**Response to NRC
Comments
on
*Assessment Report for
Well 1319 Area***

**Cimarron Corporation's Former
Nuclear Fuel Fabrication Facility
Crescent, Oklahoma**

**License Number: SNM-928
Docket Number: 70-0925**

Re: Docket No. 70-925; License No. SNM-928
Response to NRC Comments on Assessment Report for Well 1319 Area

- MONITOR WELL
- ⦿ ABANDONED MONITOR WELL
- 308.5 TOTAL U ALPHA SPEC pCi/l
- ➔ GROUNDWATER FLOW DIRECTION

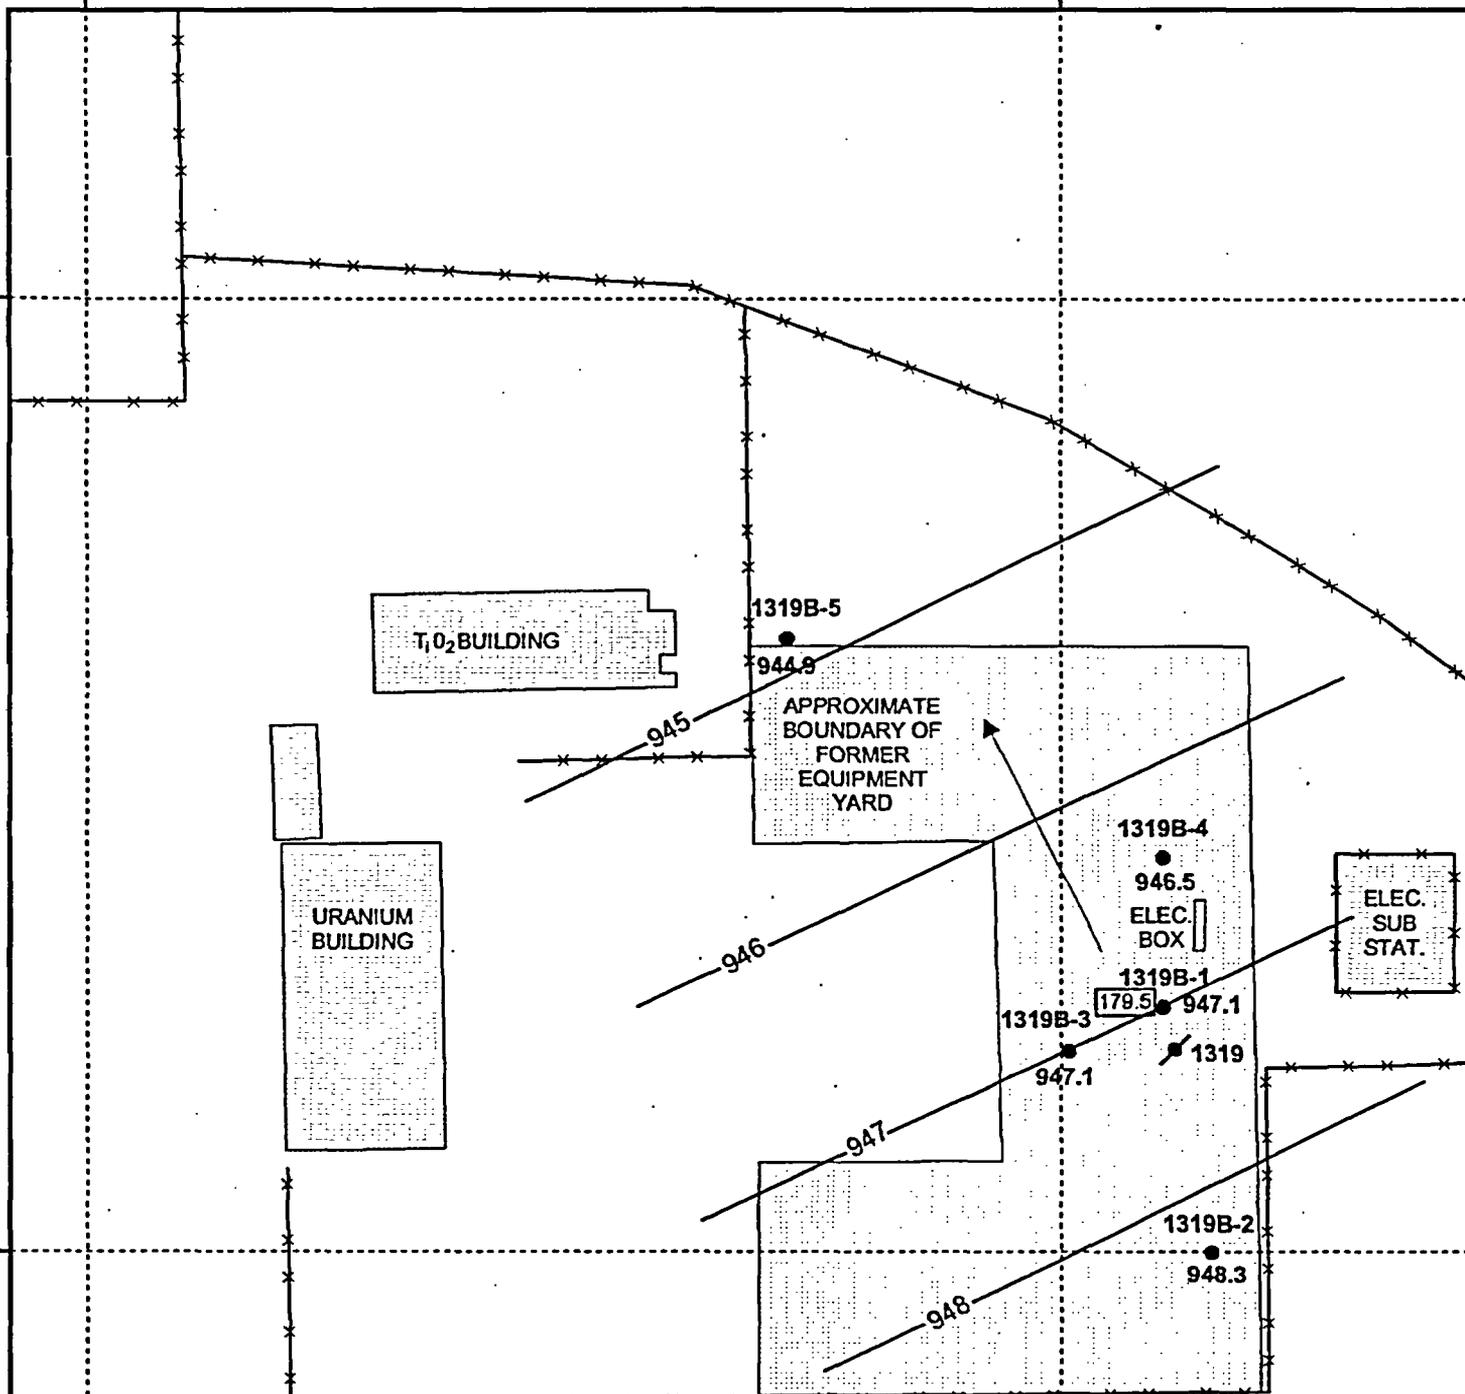
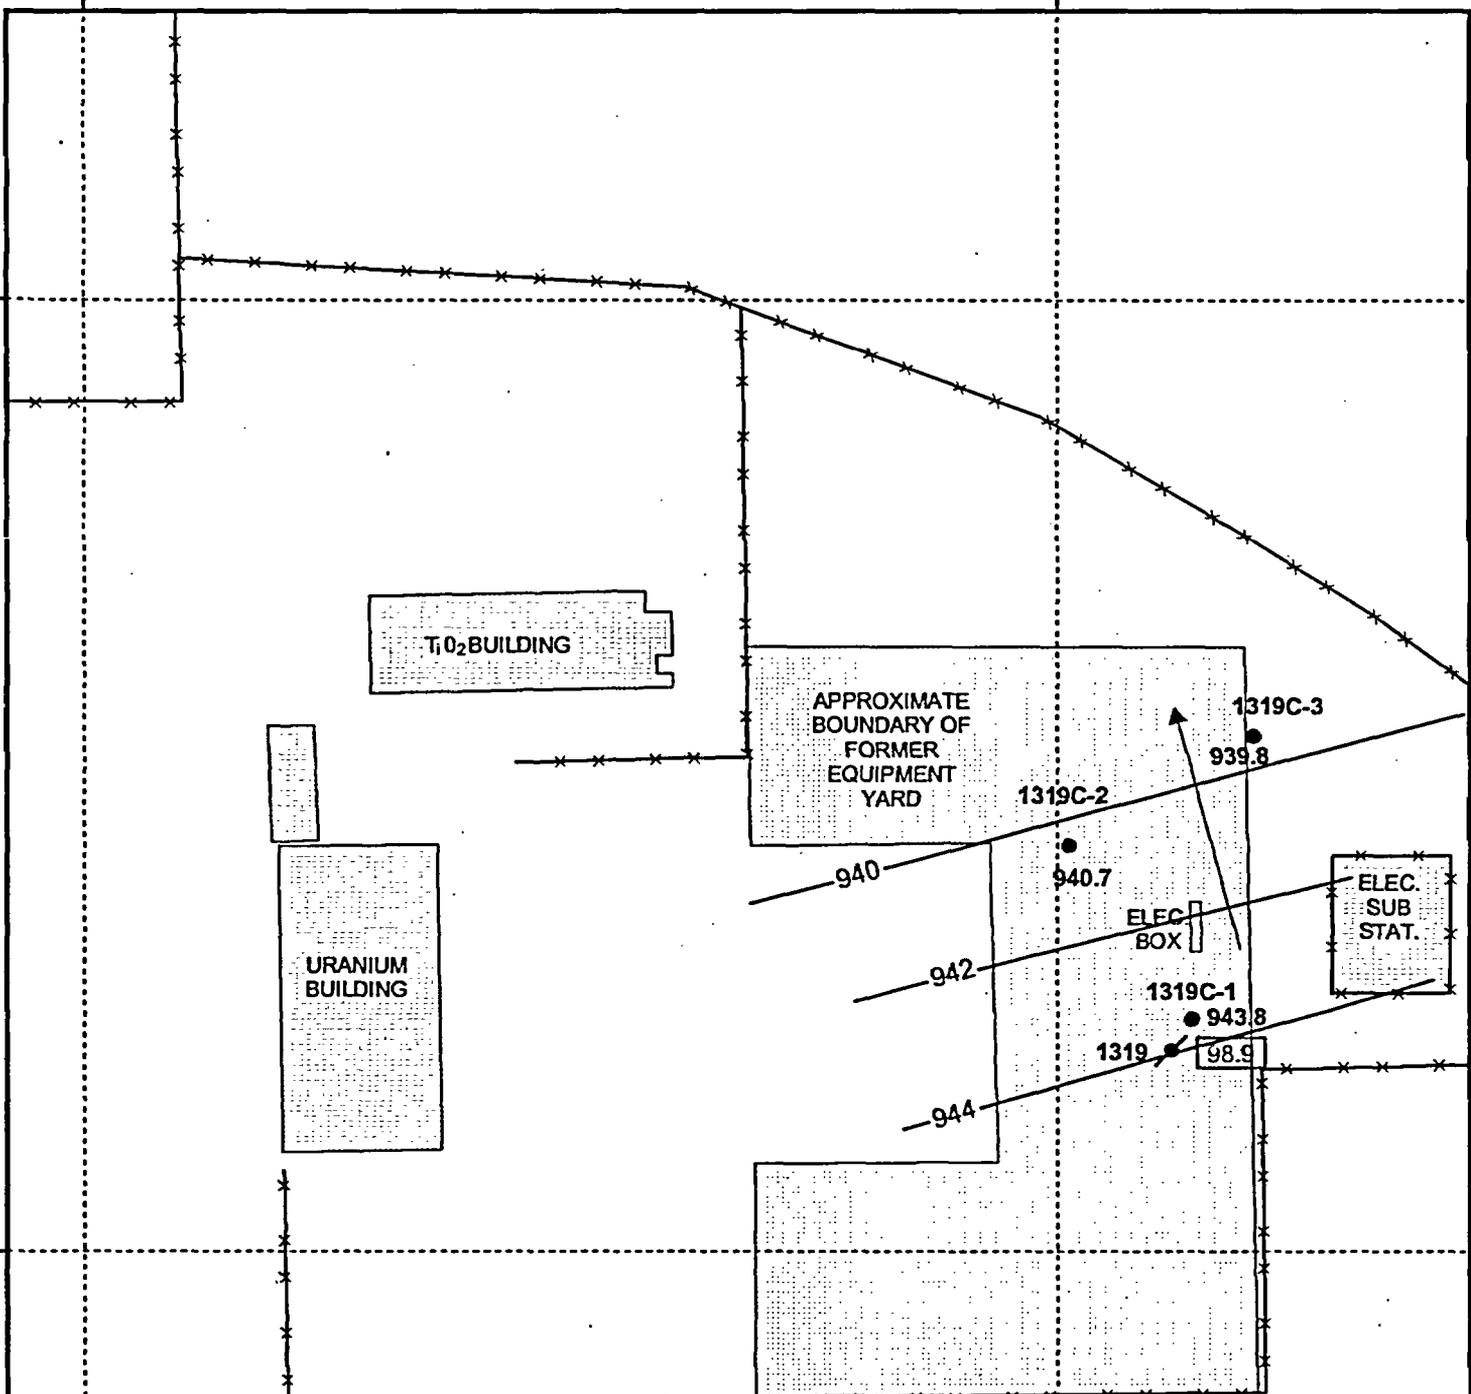
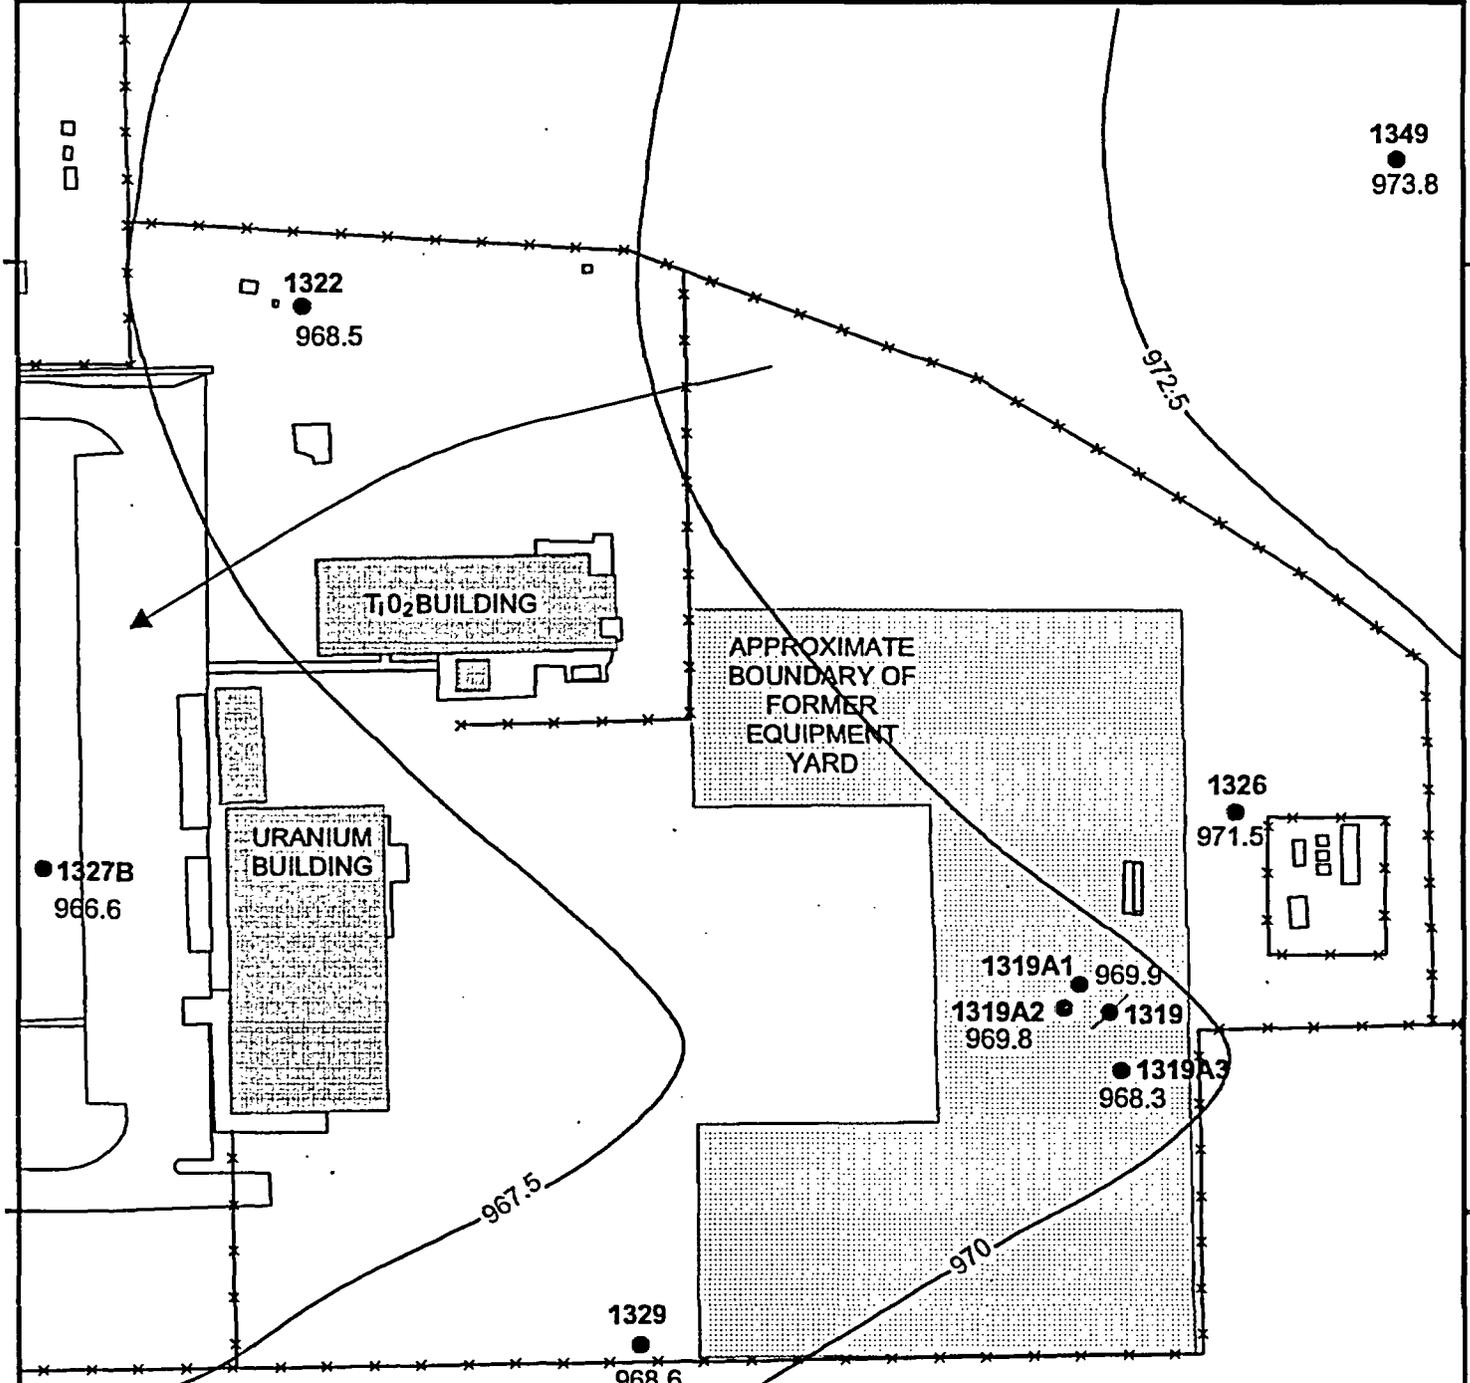
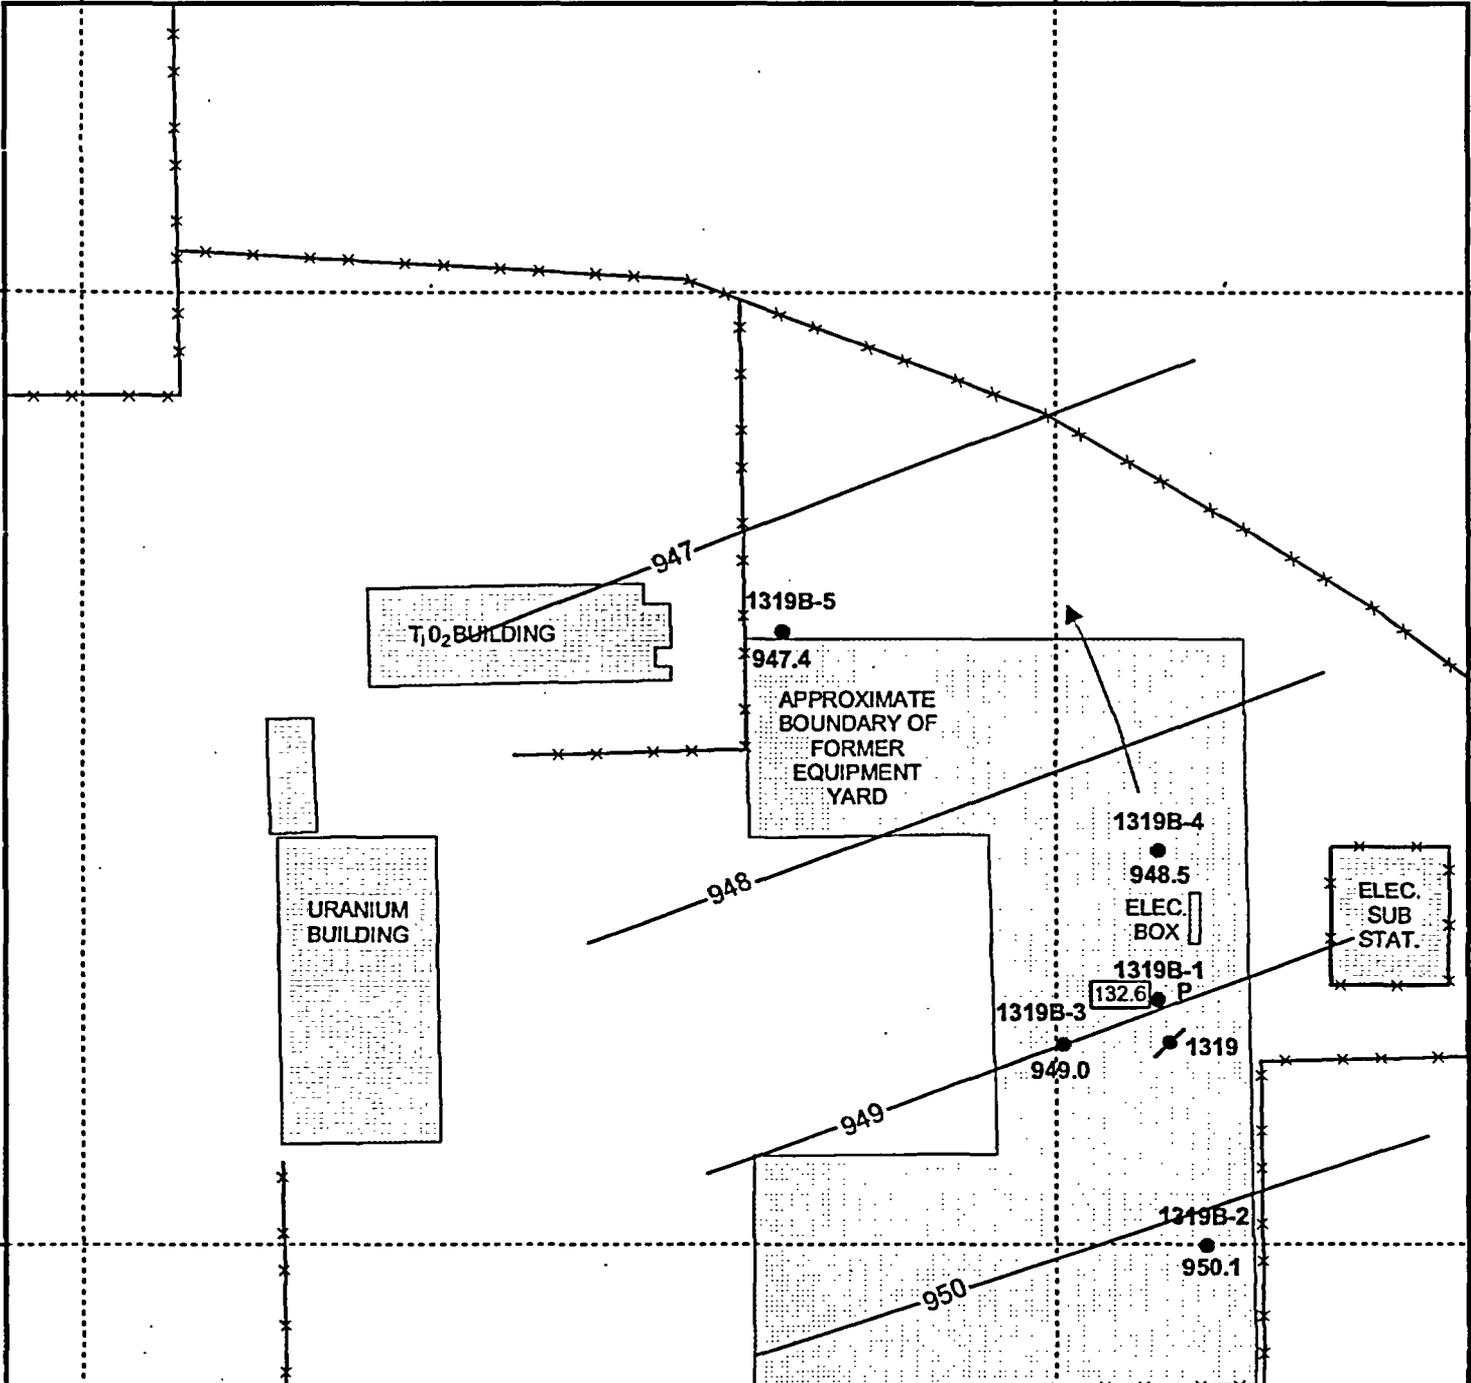
The licensee should provide additional water levels, groundwater flow directions, and total uranium analytical results since the September 2003 sampling event.

Cimarron provided potentiometric surface maps in Figures 8, 9, and 10 for Sandstones A, B, and C, respectively, in "Assessment Report for Well 1319 Area". Those maps have been updated to include total uranium concentration for the September 2003 sampling event. Groundwater elevations were recorded for wells in the Well 1319 area during the December 2003, May 2004, and August 2004 sampling events. Sets of similar figures were created for each of these three events, presenting the potentiometric surface and groundwater flow directions for each of the three sandstone units. Total uranium concentrations are not shown on all figures because only Wells 1319B-1 and 1319C-1 were sampled during some events. Most of the wells in the area were sampled during the August 2004 sampling event, so figures for that event include total uranium concentrations for all wells in the Well 1319 Area that were sampled. These figures are included in this submittal as Attachment 4.
